Town of Rolesville, NC
Department of Planning

Comments on #SDP-26-0007 - Planning & Zoning: Site Development Plan

Application Number: #SDP-26-0007
Application Type: Site Development Plan
Date: September 11, 2026
Address: 408 E YOUNG ST, ROLESVILLE, NC 27571
Parcel: 1768098727

SHEET NUMBER:
C-0.00

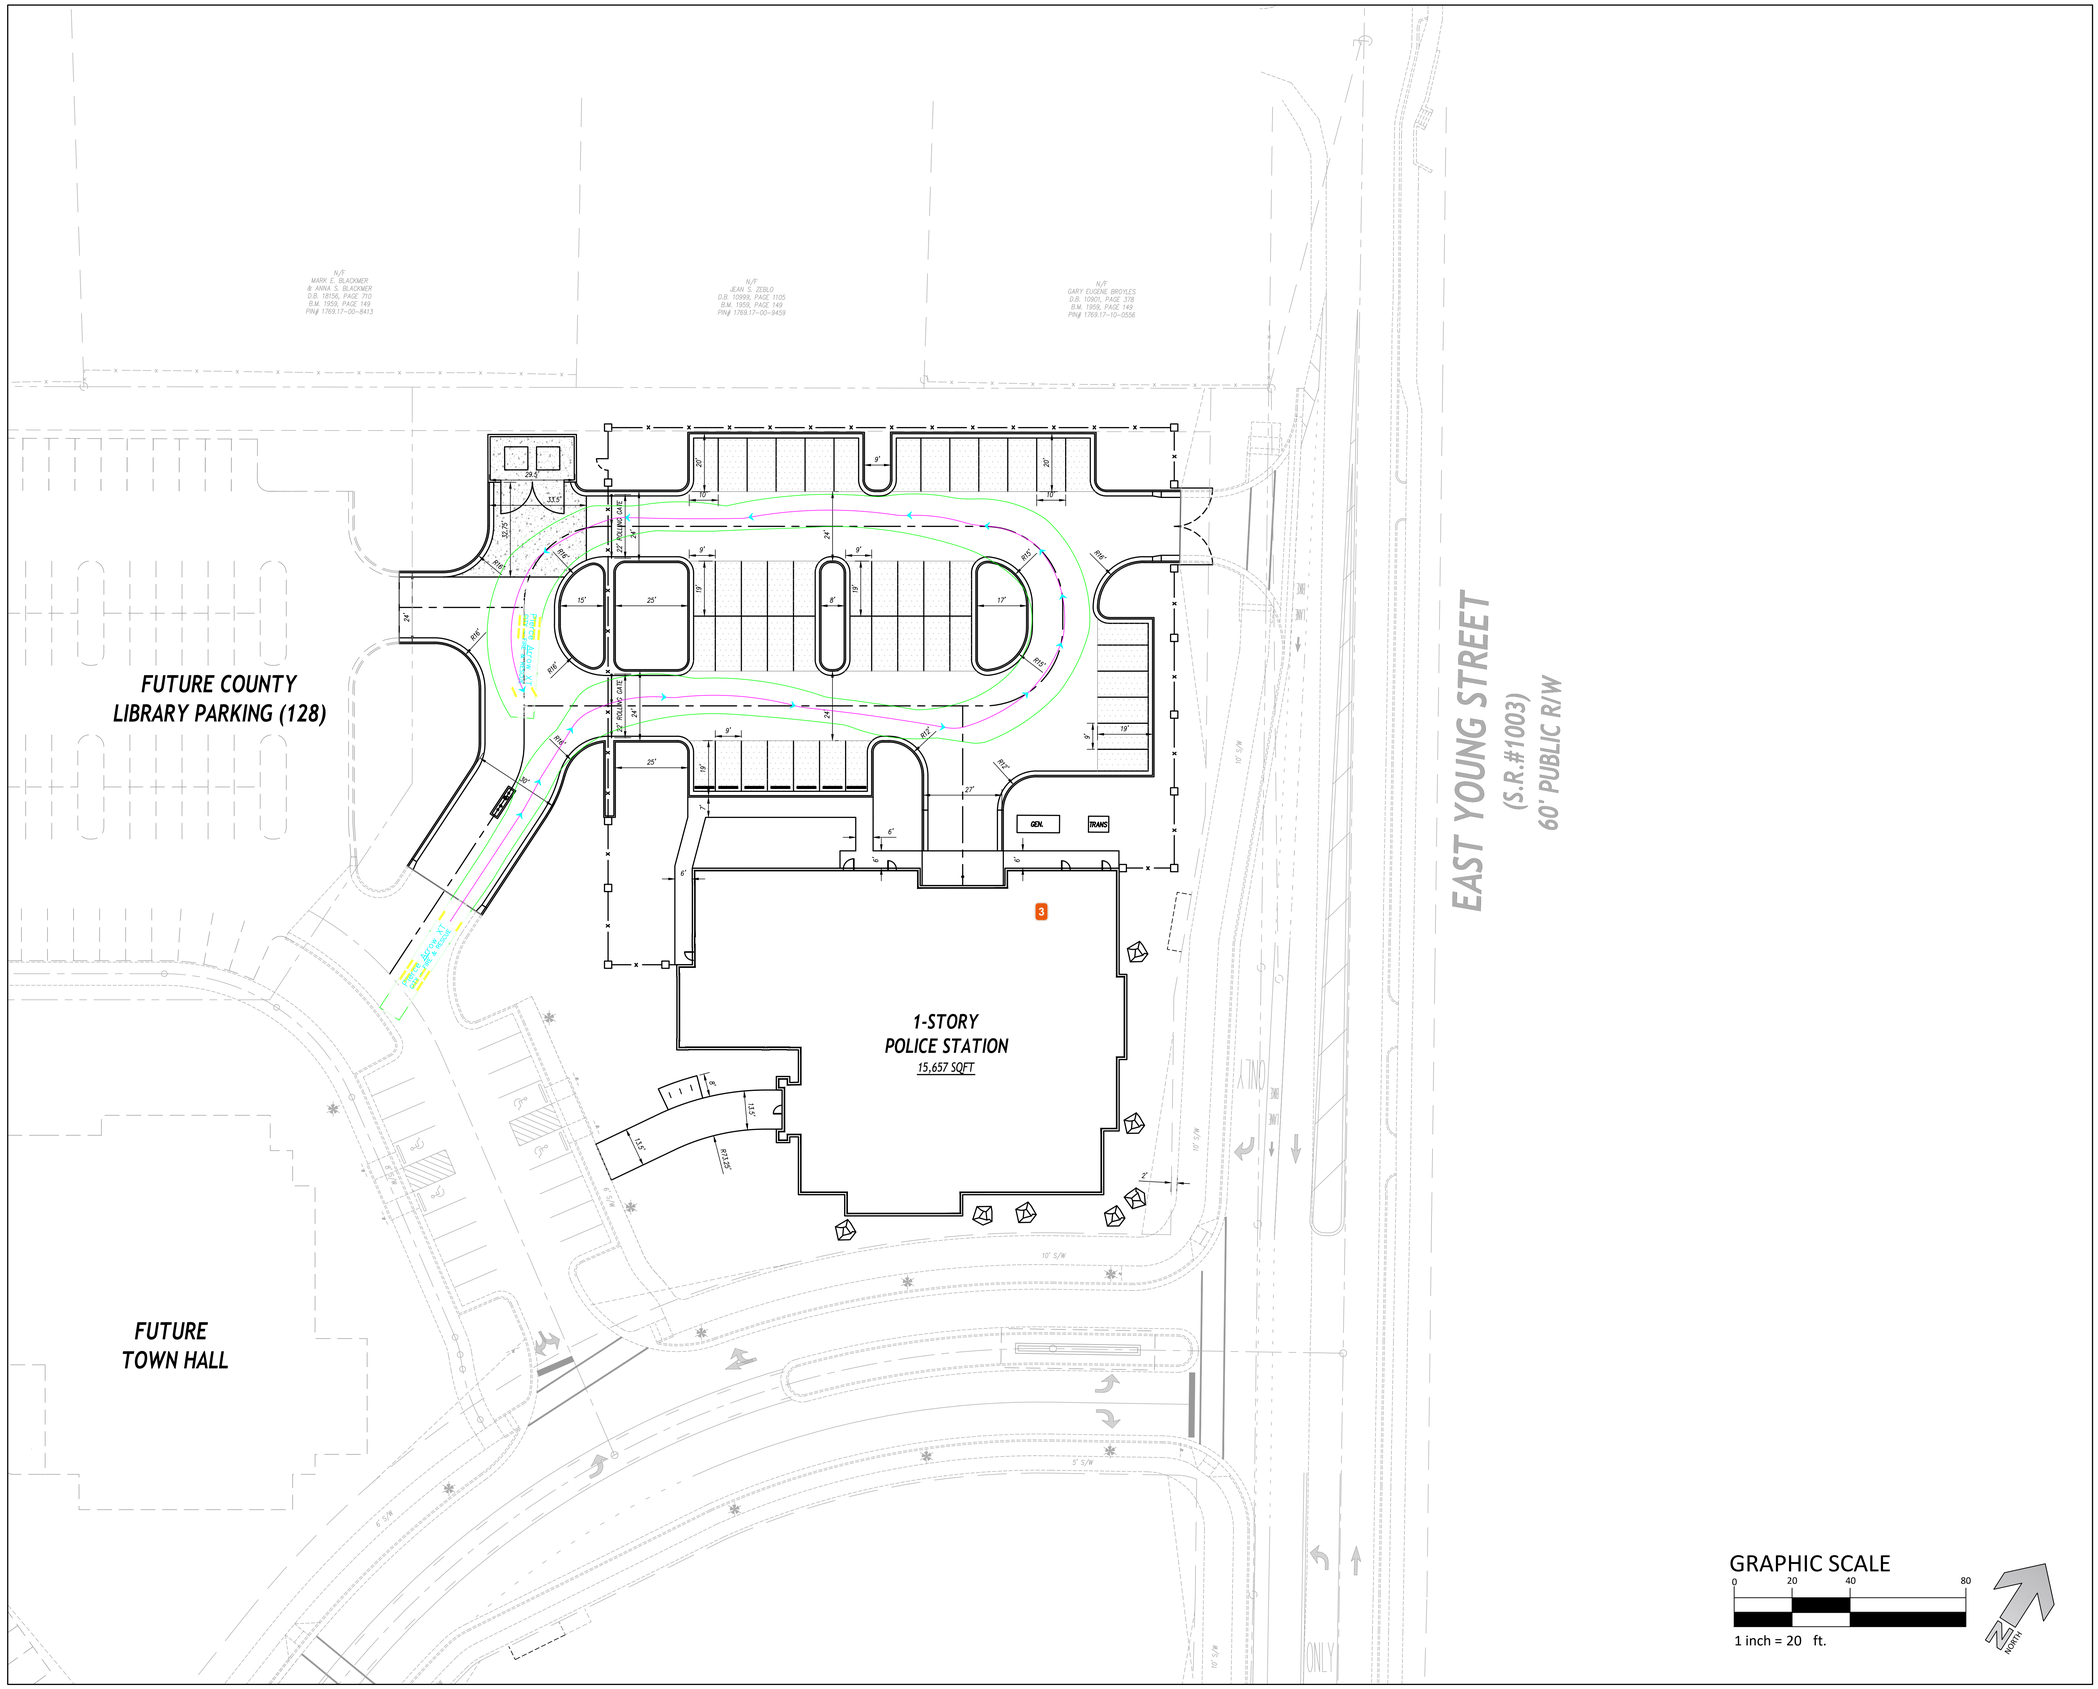
Please include pre and post impervious and pervious numbers.

Pls add PSP-26-0004.

2 **Michele Raby**
Pls add PSP-26-0004.

C-0.02

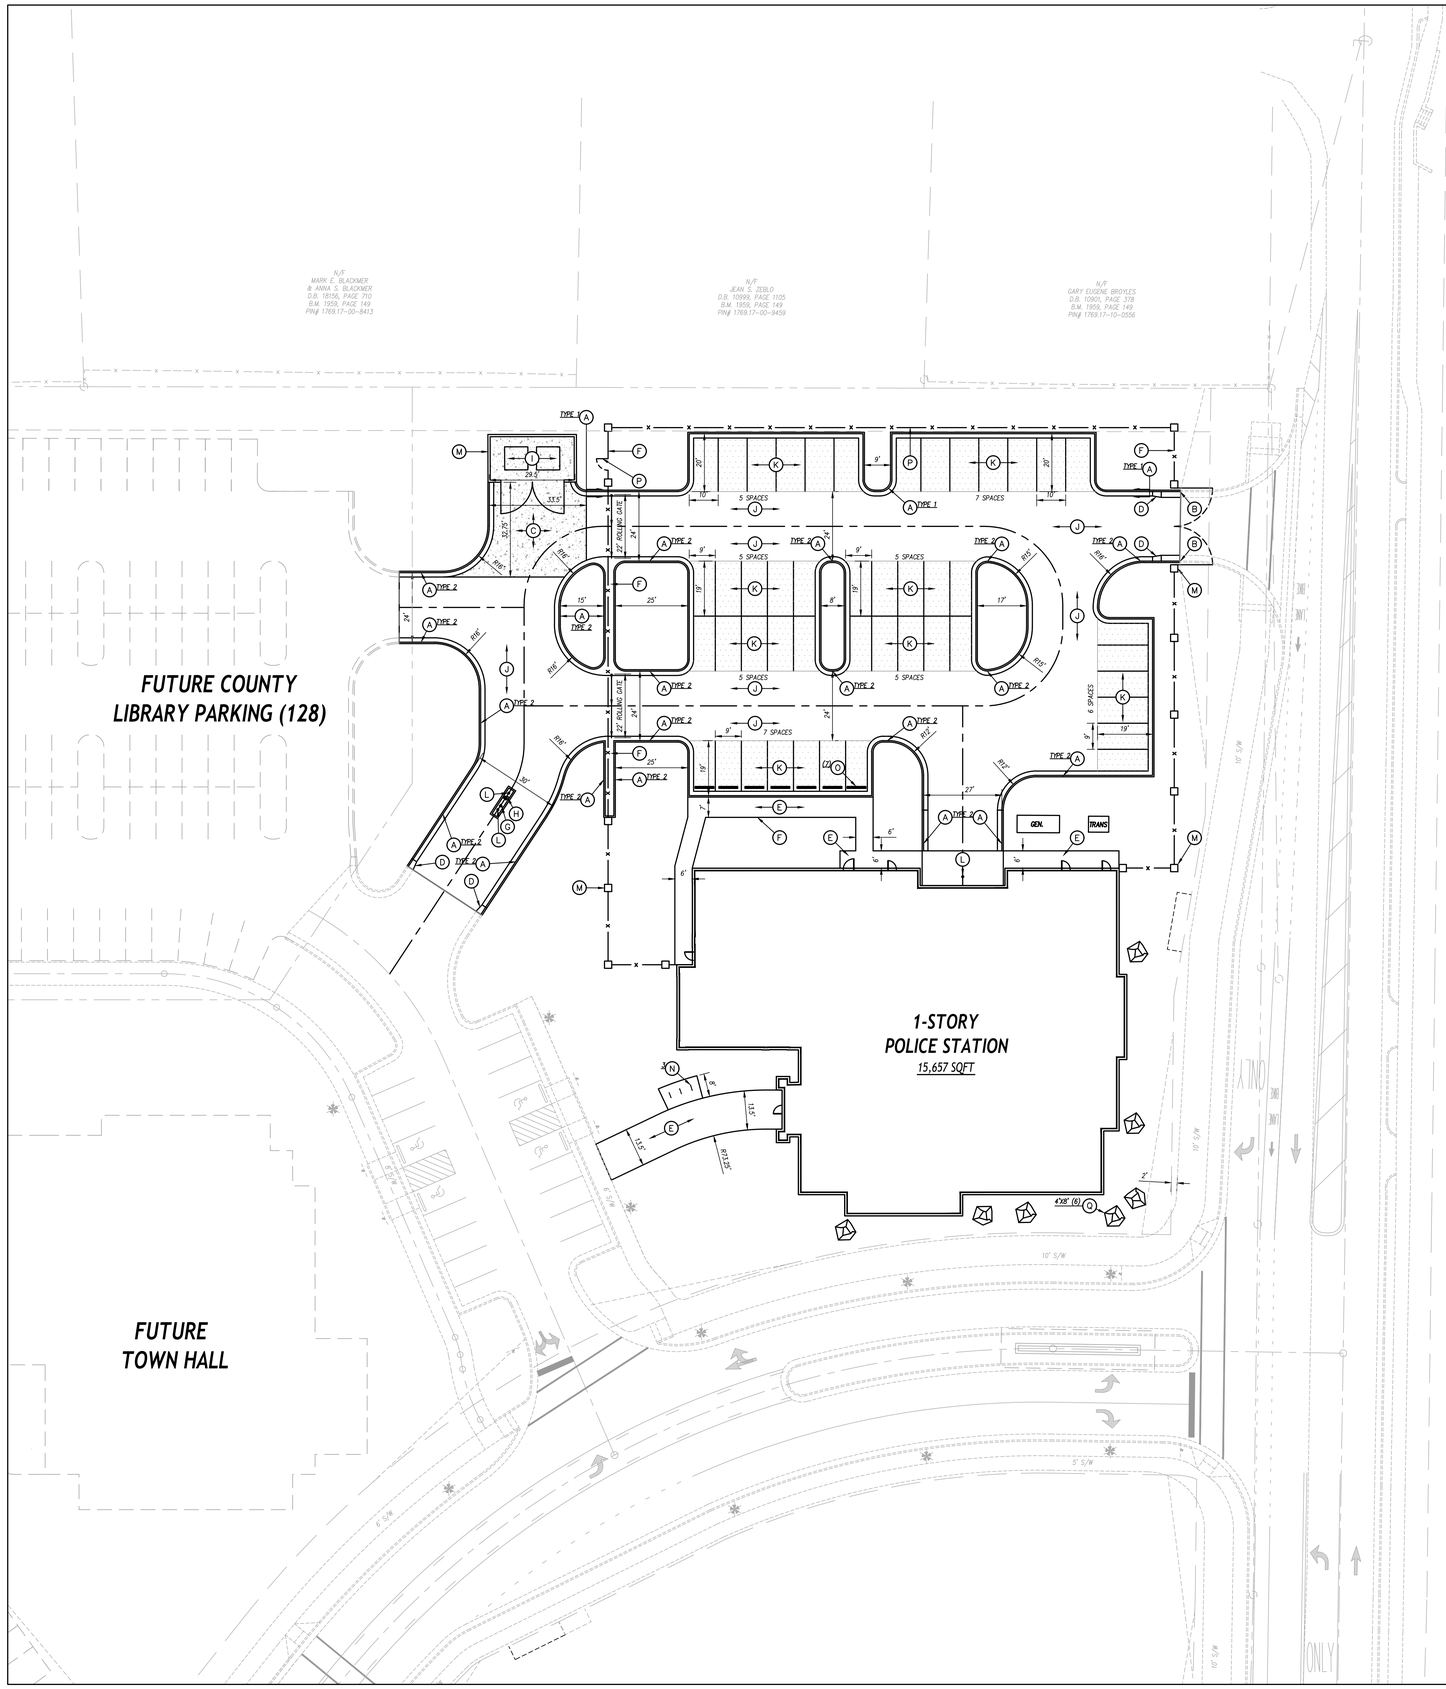
** No fire service issues with the initial site plan for the Rolesville Police Station.

3 **Stephen Wolf**
** No fire service issues with the initial site plan for the Rolesville Police Station.

C-1.01

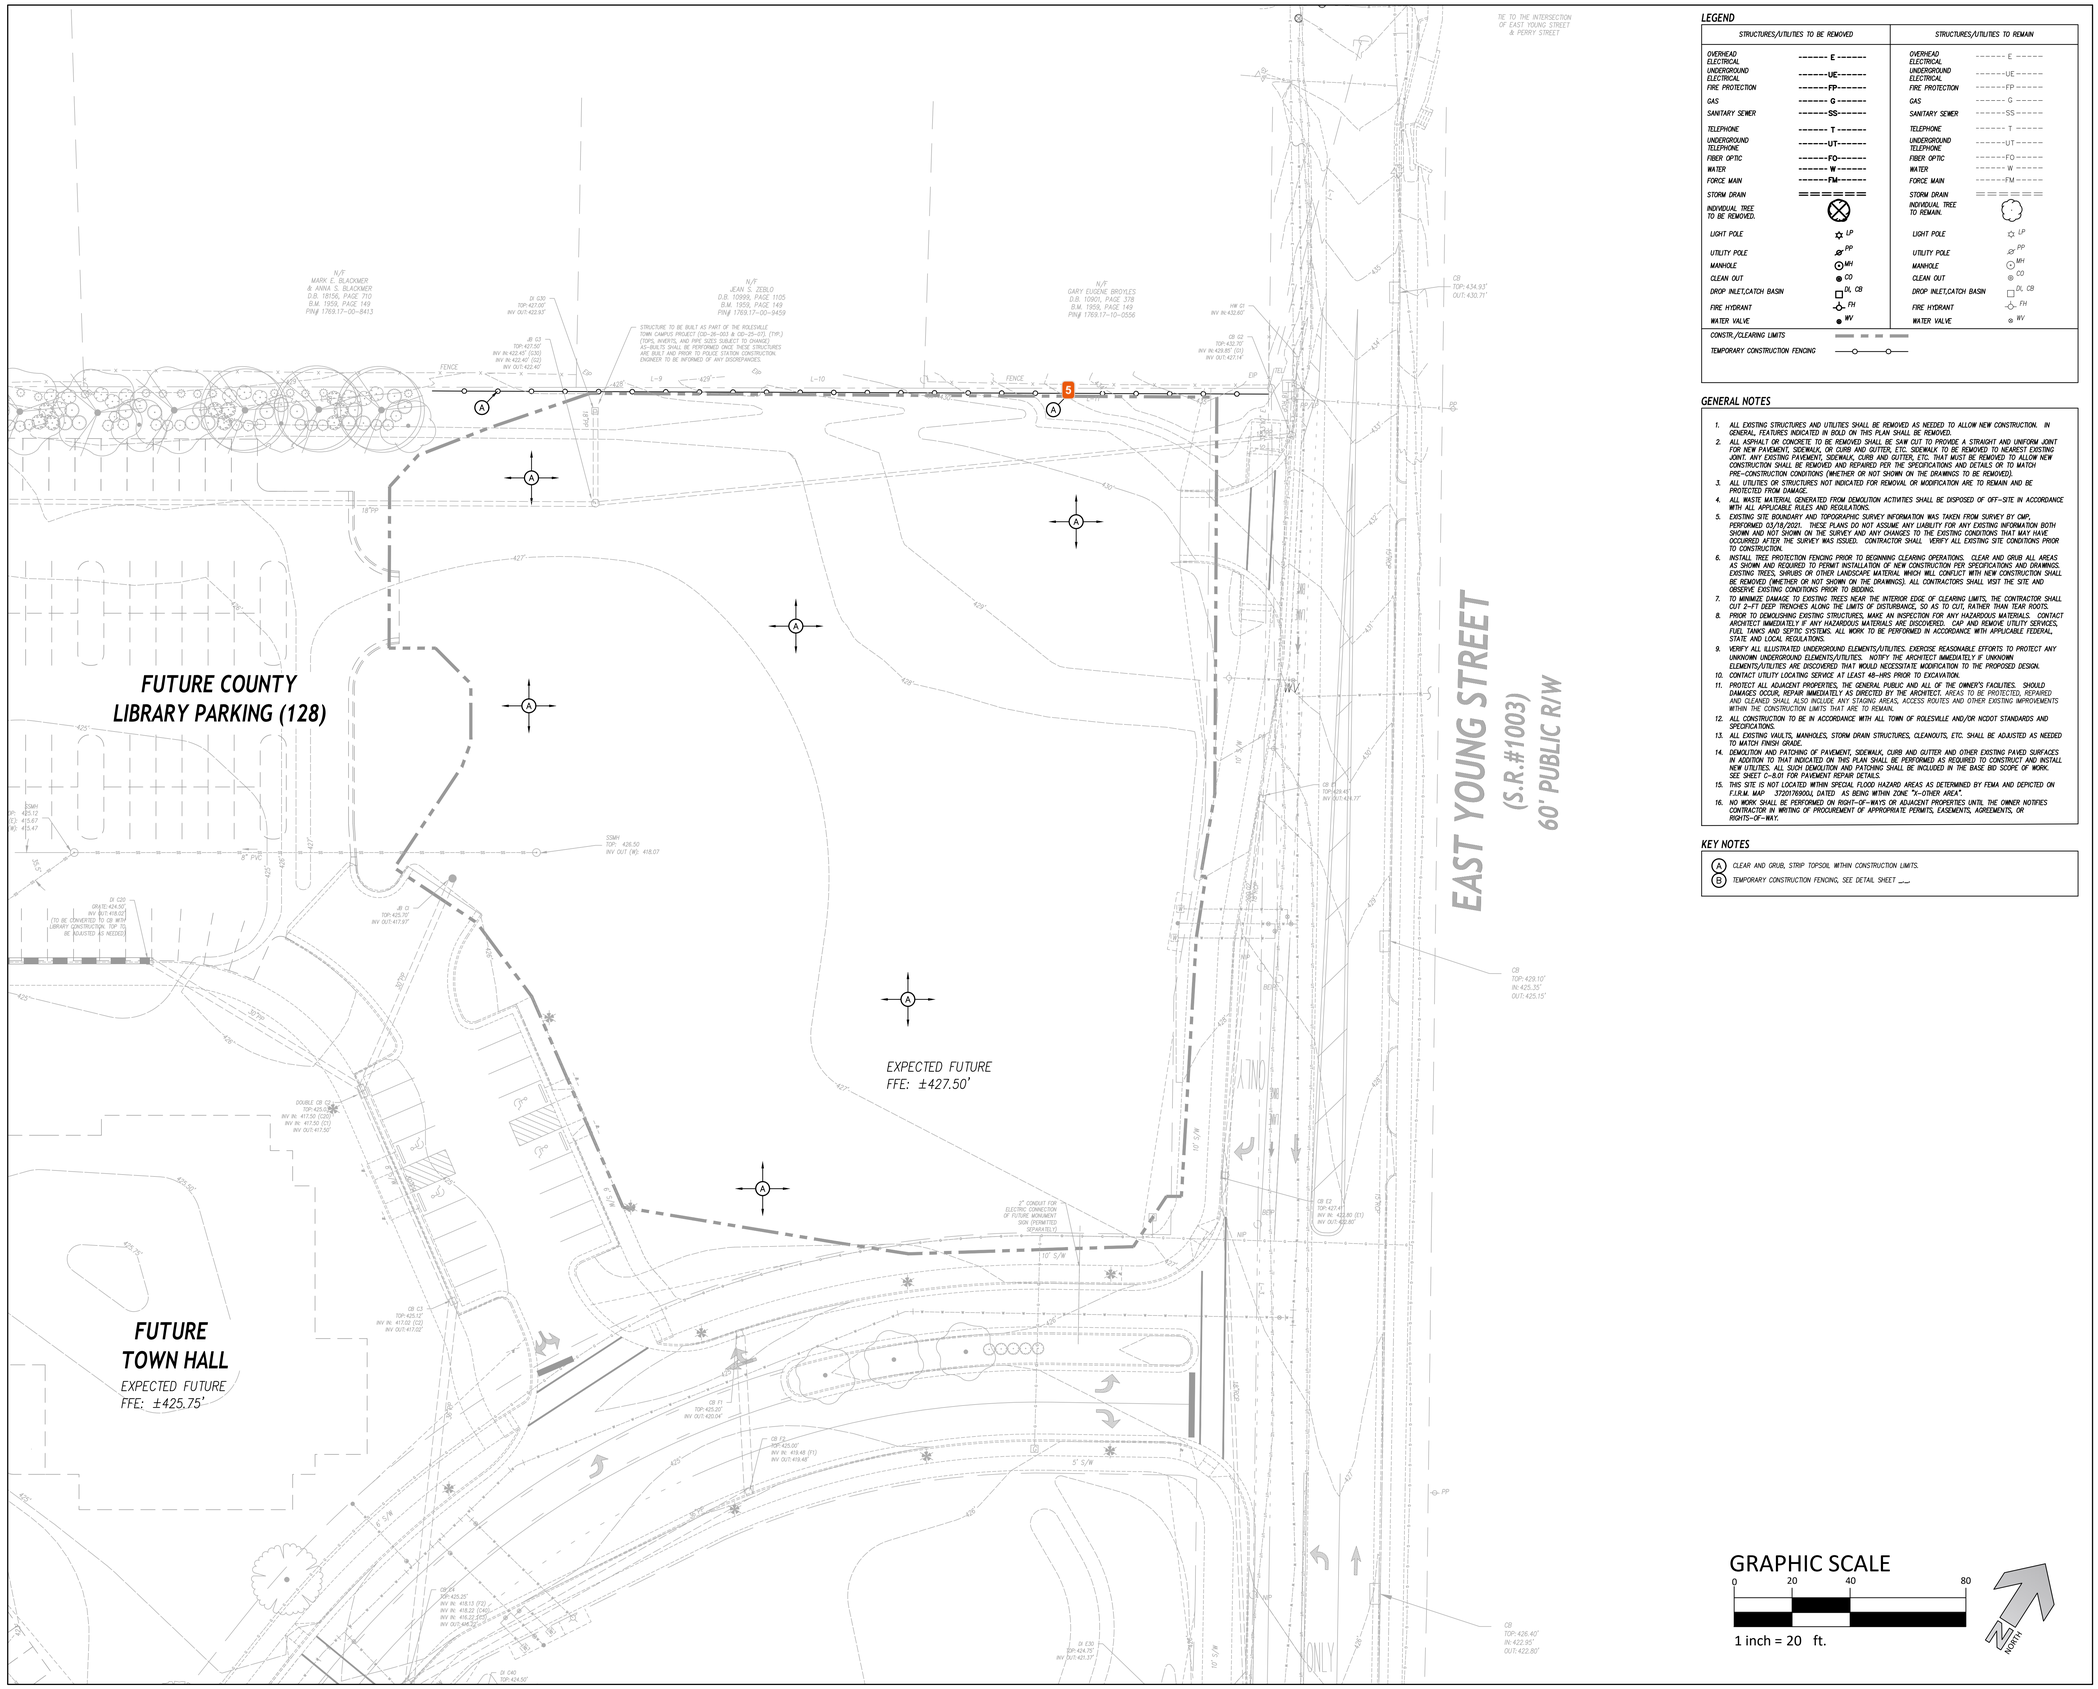
Update all sheet references.

4 **Jacqueline Thompson**
Update all sheet references.
